To	Department of Planning, Industry and Environment (DPIE) C/o Andrew McSwan (Mace Group)	From	Hayden Calvey, Cardno
Date	6 August 2021		
Project	Samuel Gilbert Public School (SGPS)	Discipline	Traffic and Transport
Subject	Drop-off / Pick-up & Parking Review for Modification Application

Figure 1-1 Approved Kiss 'n Drop Modifications

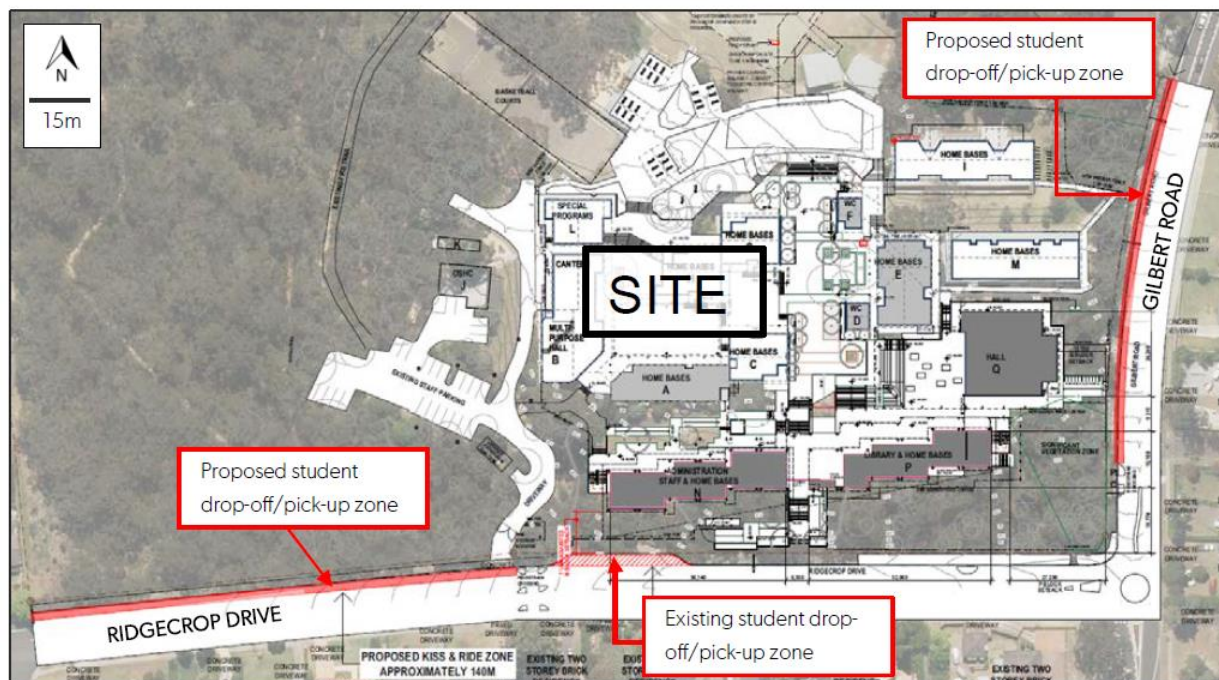
As part of the approval, the redevelopment is to modify the current drop-off / pick-up (DOPU) arrangement on Ridgeway Drive to be split between Ridgeway Drive and Gilbert Road as per the recommendations contained within the Traffic Impact Assessment (TIA) dated 6 May 2019 (TSA). This is generally shown in **Figure 1-1**. In addition to the DOPU arrangement, an additional four on-site car parking spaces were to be provided.

The suggested lengths of 140m to the west of the wombat crossing on Ridgecrop Drive appears to impact an existing traffic calming device within the parking lane and extends across the Galahad Rd intersection. The legal parking length between the traffic calming device and the crossing is some 105m in the afternoon.

Figure 4-2 Proposed Parking Arrangement

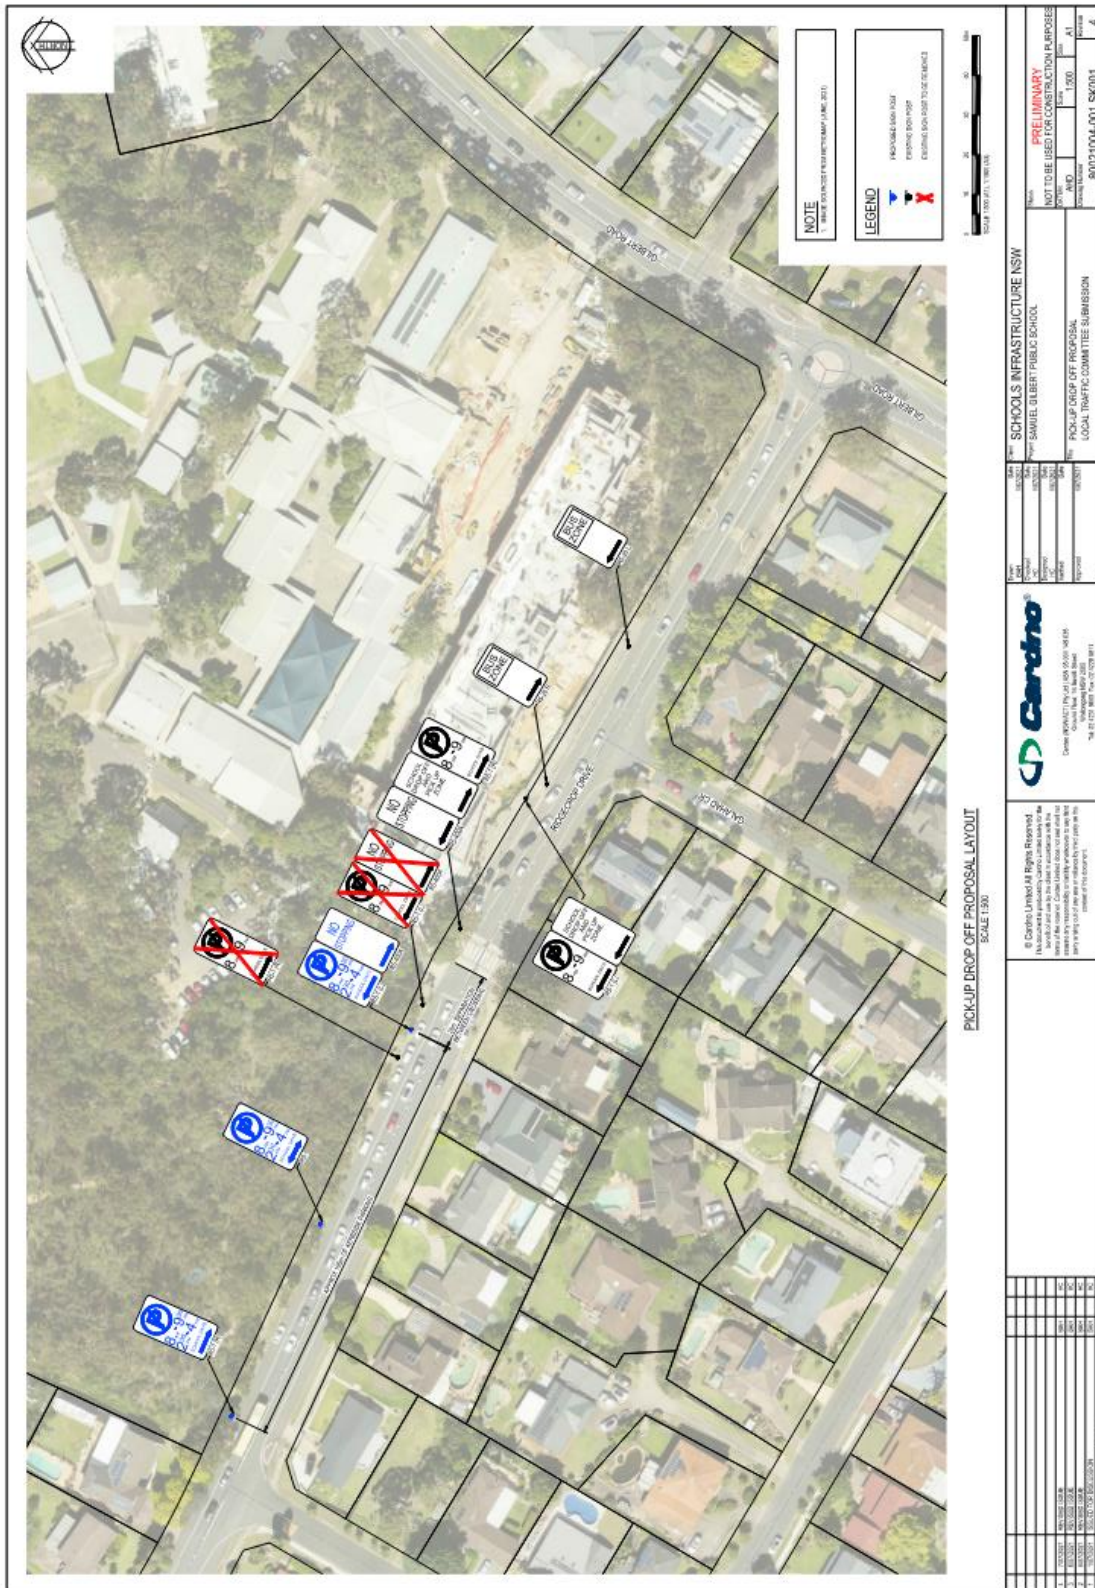
The subsequent kerbside parking arrangement on Ridgescrop Drive, submitted to LTC, is shown in **Figure 4-2**. It is also relevant to note that the verge adjacent to the DOPU zone will be modified to provide a flat concrete area between the current footpath and back-of-kerb as requested by Council.

Based on Cardno's review of the SSD DOPU analysis, SSD approval, understanding of the Green Travel Plan requirements, site observations and student survey, it is recommended that the 272m of DOPU zone required and split between Ridgescrop Drive and Gilbert Road is reduced to some 105m in length and contained to Ridgescrop Drive only.
